TOWN OF BROOKFIELD
ARCHITECTURAL REVIEW COMMITTEE MINUTES
AUGUST 13, 2025

TOWN OF BROOKFIELD ARCHITECTURAL REVIEW COMMITTEE STAFF REPORT

MEETING DATE: September 10, 2025

West elevation (facing parking lot)

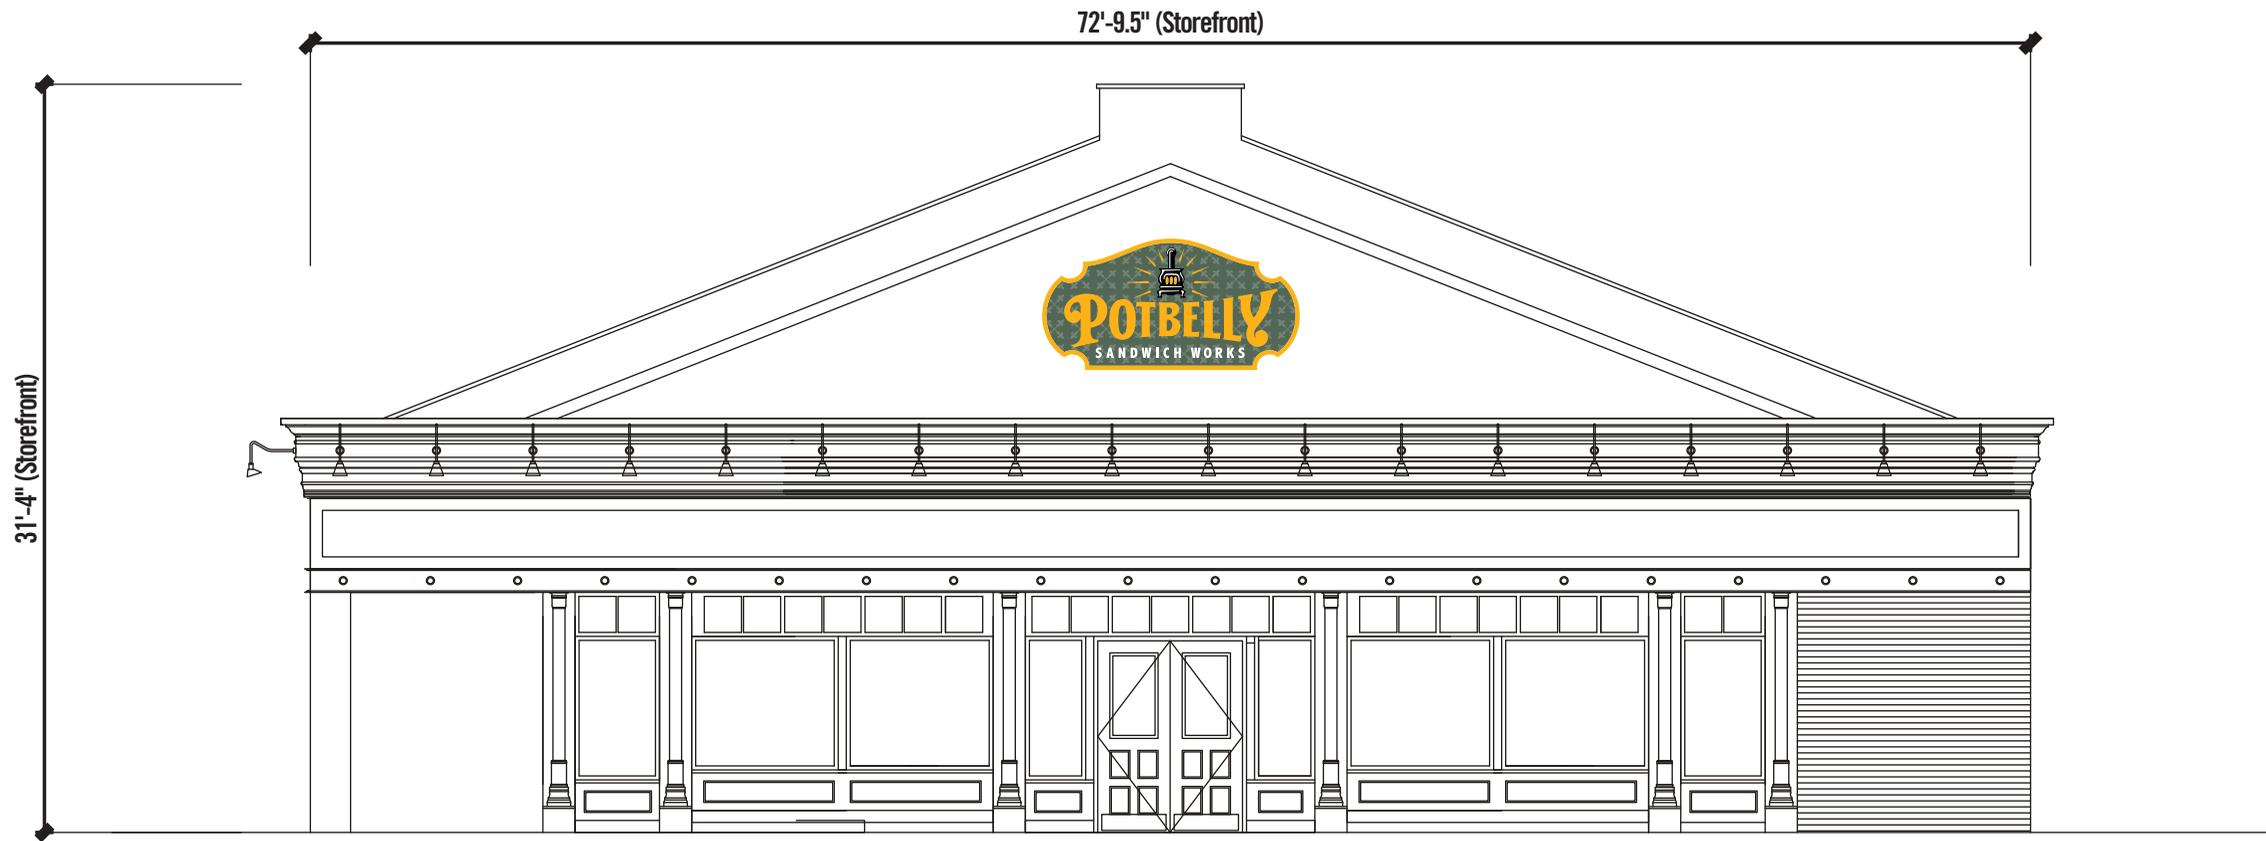
Potbelly's is located on the north side of Bluemound Road within a multi-tenant building and has frontage along Bluemound Road. Potbelly's is requesting to install two new wall signs with revised franchise logos in place of the existing signs on the south and west elevations.

- Proposed wall sign is 58 sq. ft. (58.2 sq. ft. permitted)

- Proposed wall sign is 28.75 sq. ft. (30.2 sq. ft. permitted)

Both signs are centered over the entrance and width of their perspective storefronts. The signs are internally lit with a green background with yellow and white lettering. The signs do not face adjacent lands that are zoned or used for single-family or duplex use. The proposed signs comply with the Section 17.08 of the Zoning Code.

1 PROPOSED - WEST ELEV SIGN - 286 SF
2 1/4" = 1' - 0" SCALE

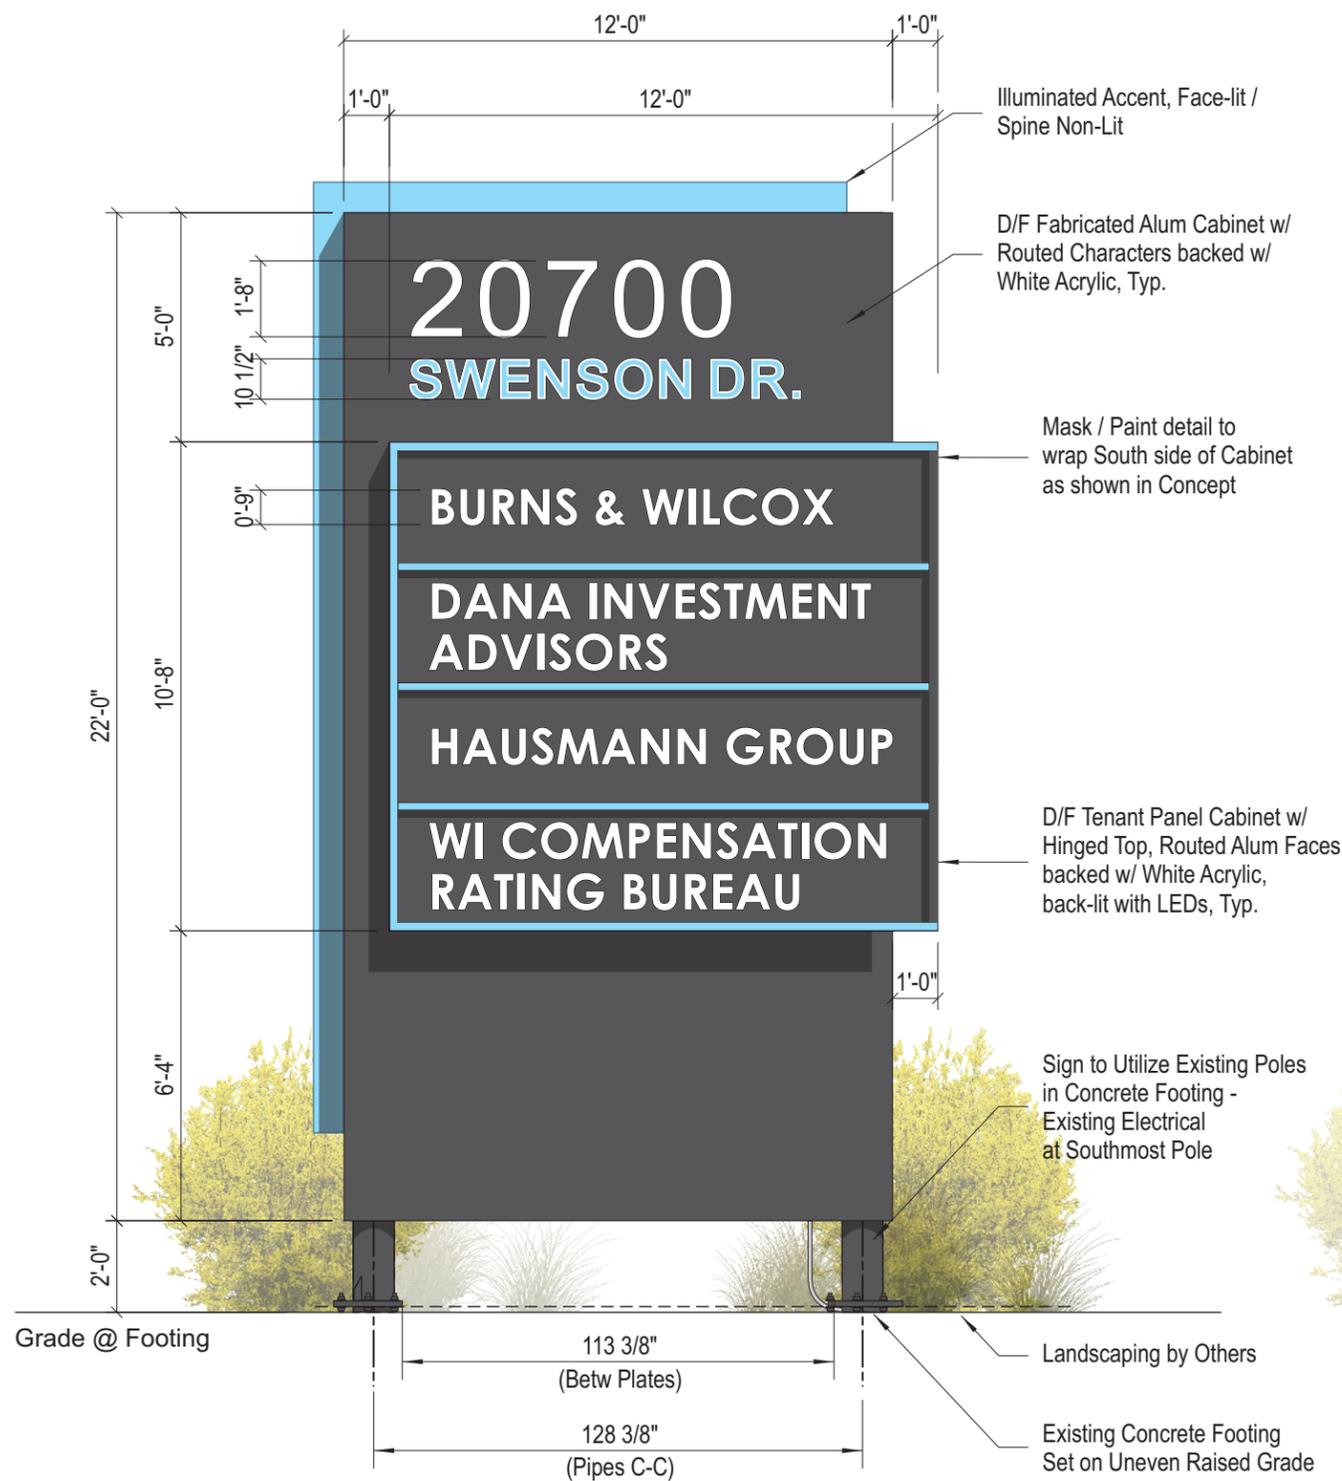
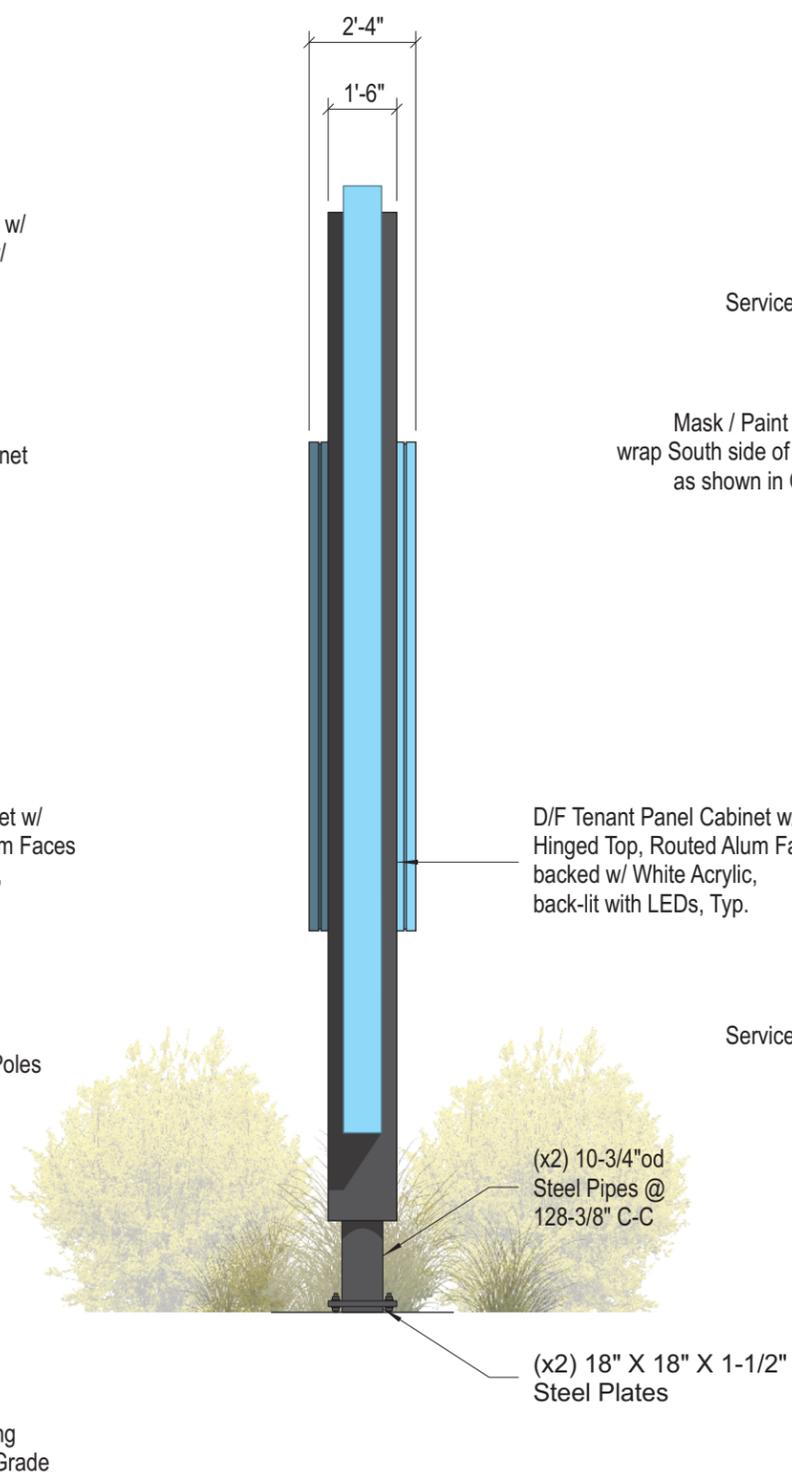
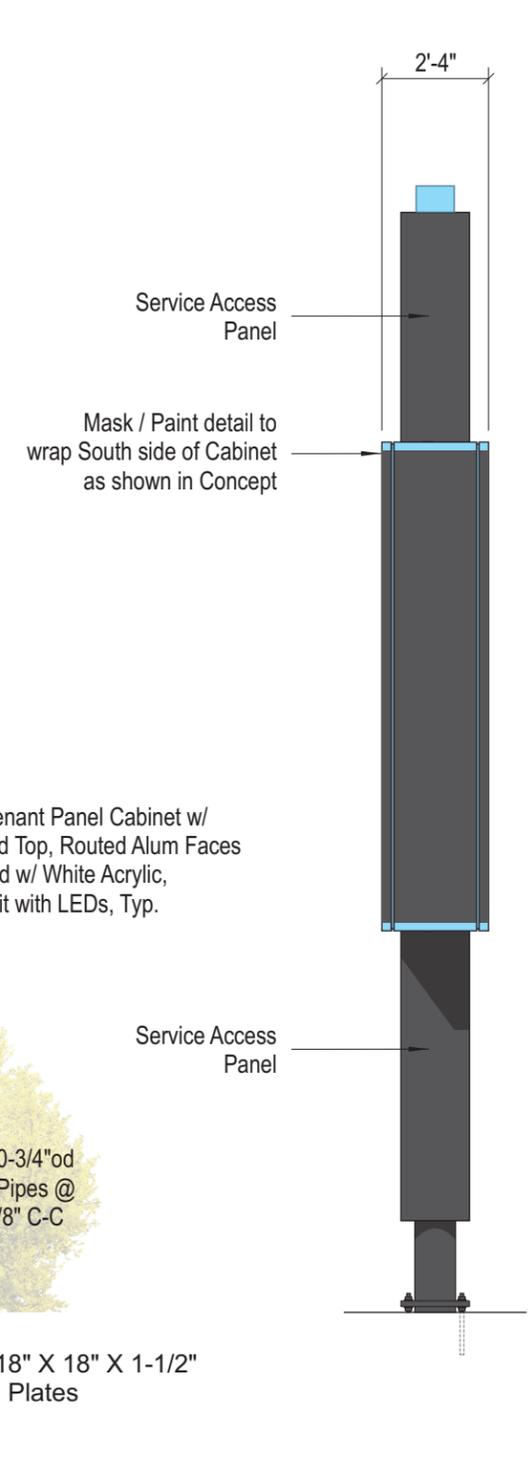
Proposed Sign - 286 SF
to Replace Existing

SITE PLAN
A0.41

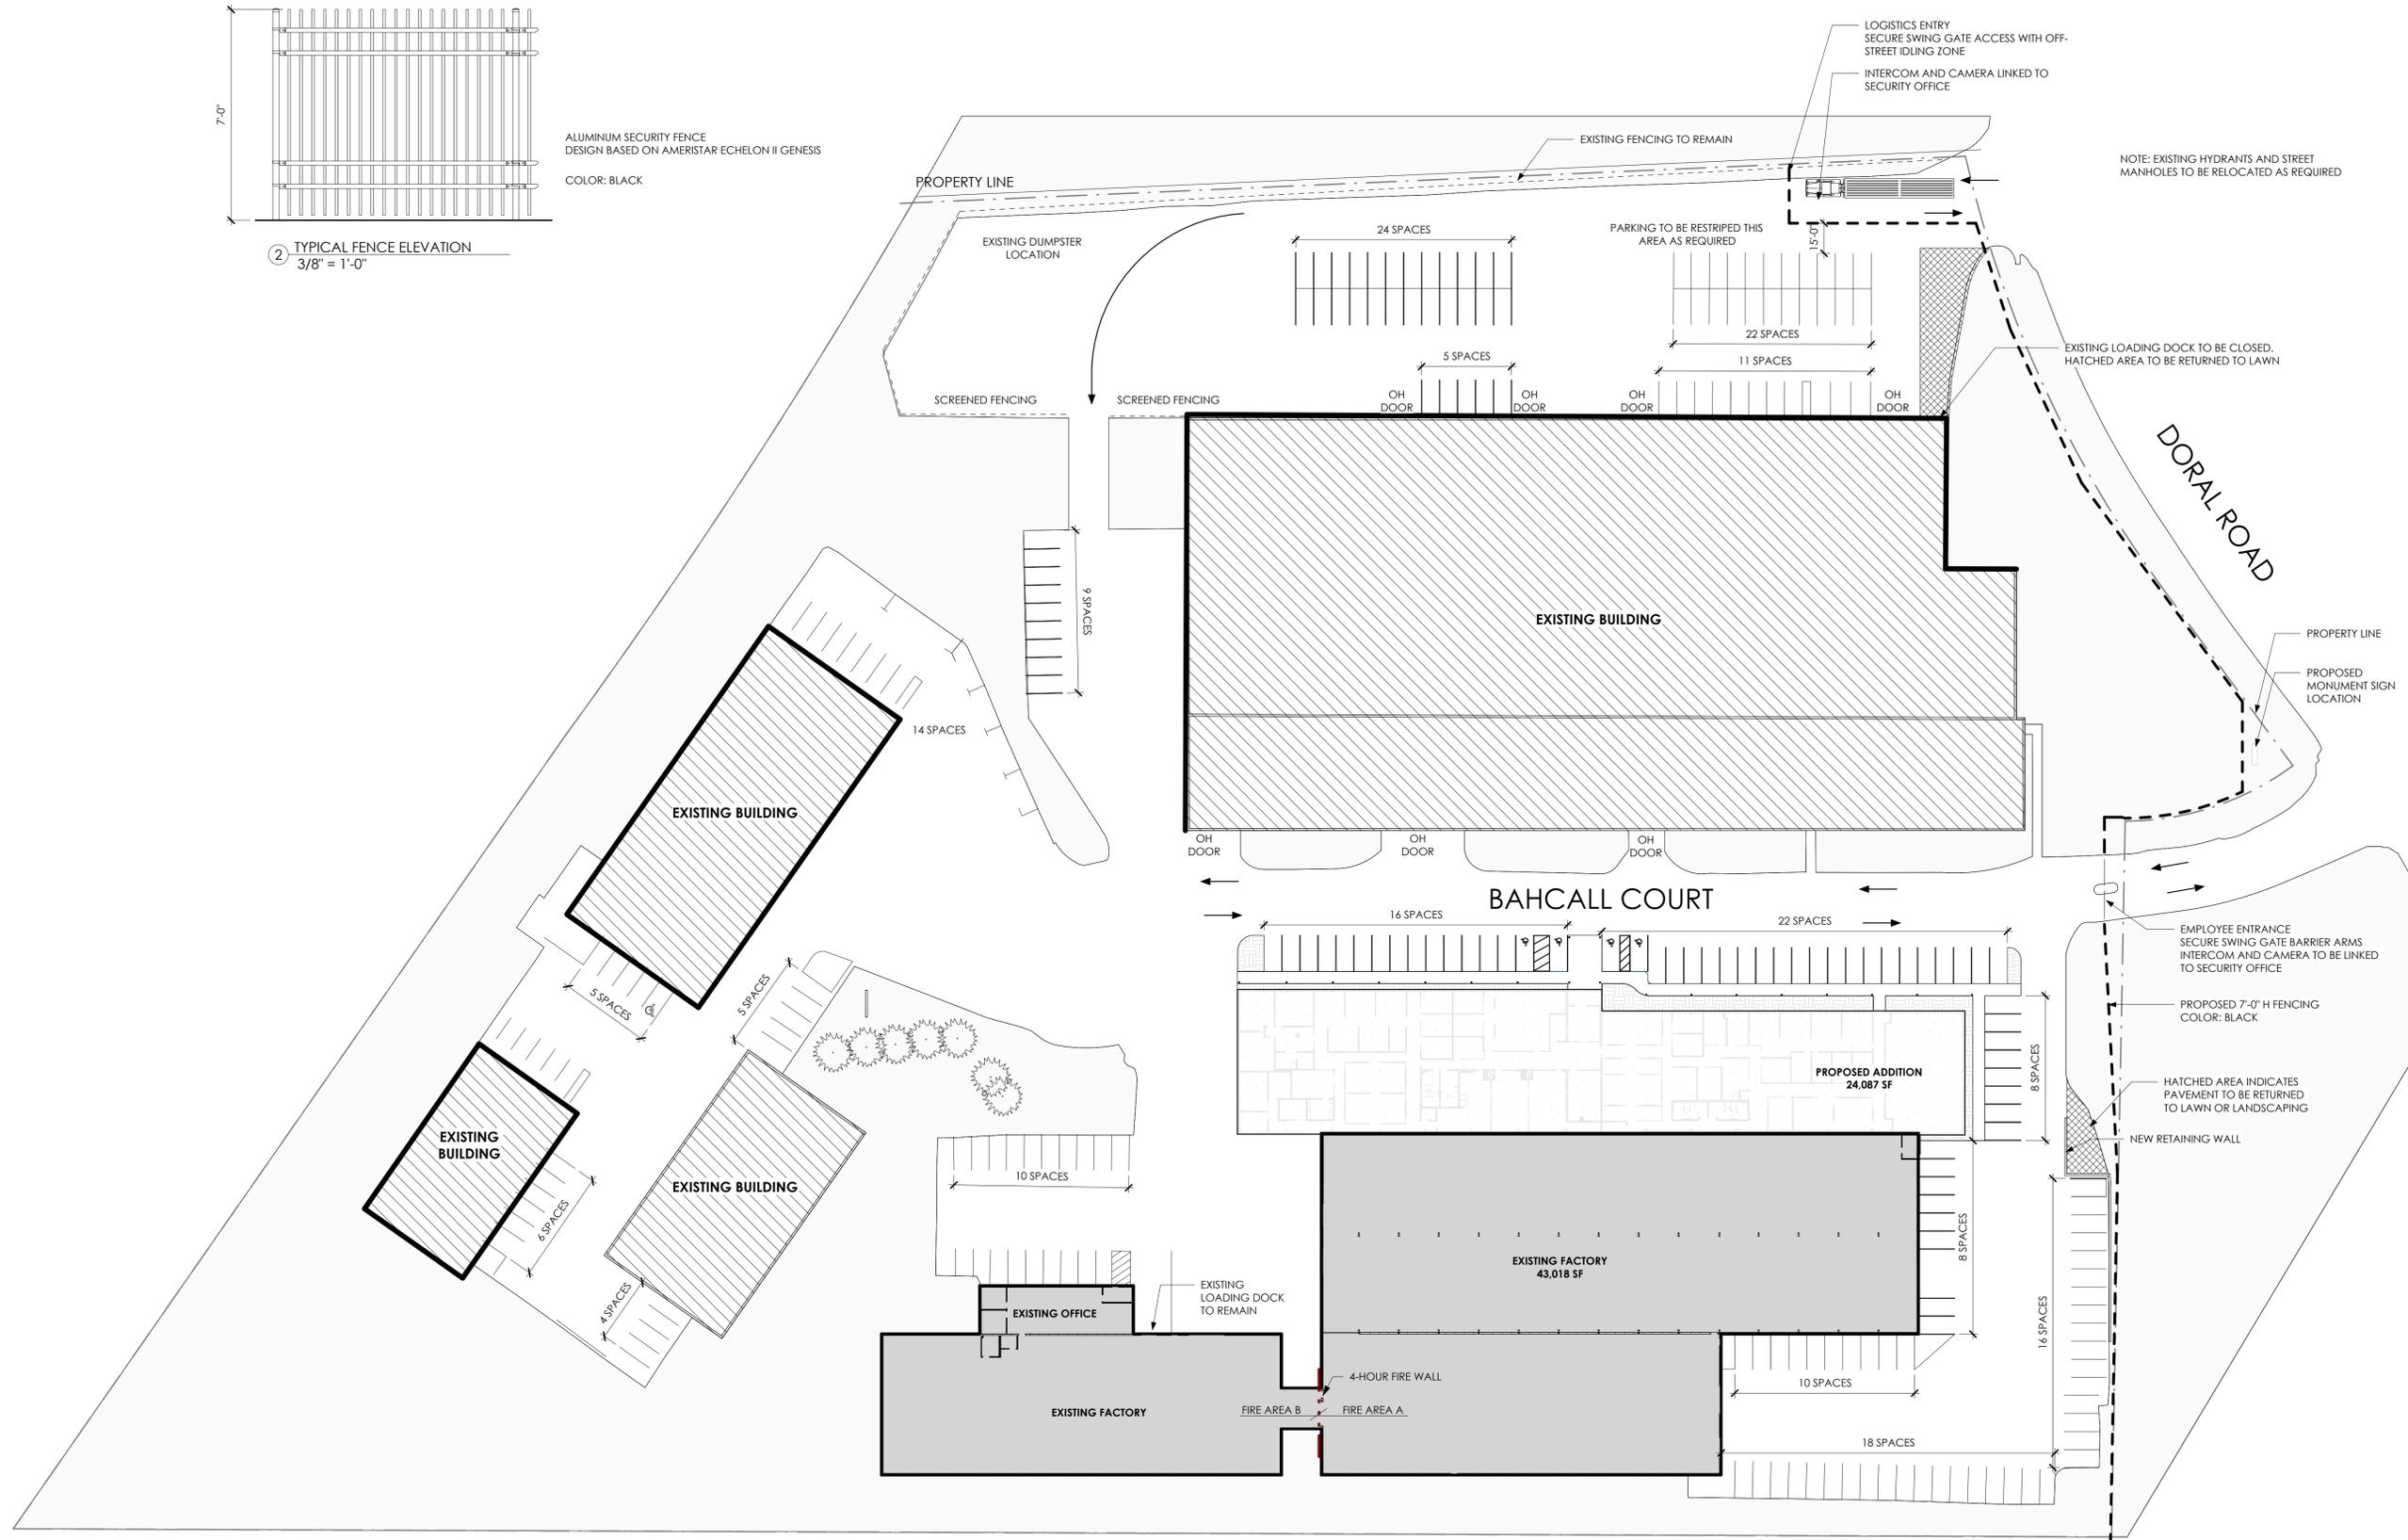
Access: Two existing access points to Doral Road will remain unchanged. New swing-up type gates will be installed at both access points that will have cameras and a security intercom linked to the security office. Semi-trucks will utilize the west entry to allow a full-size trucks to park clear of the street. Access must be requested from KHS security to enter the site. The applicant is working with the fire department to create an emergency plan for the swing up gates.

Fencing: An existing chain link fence is along the west property line and is not proposed to change. A new seven (7) foot tall black aluminum fence will be installed along the north property, outside of the right of way.
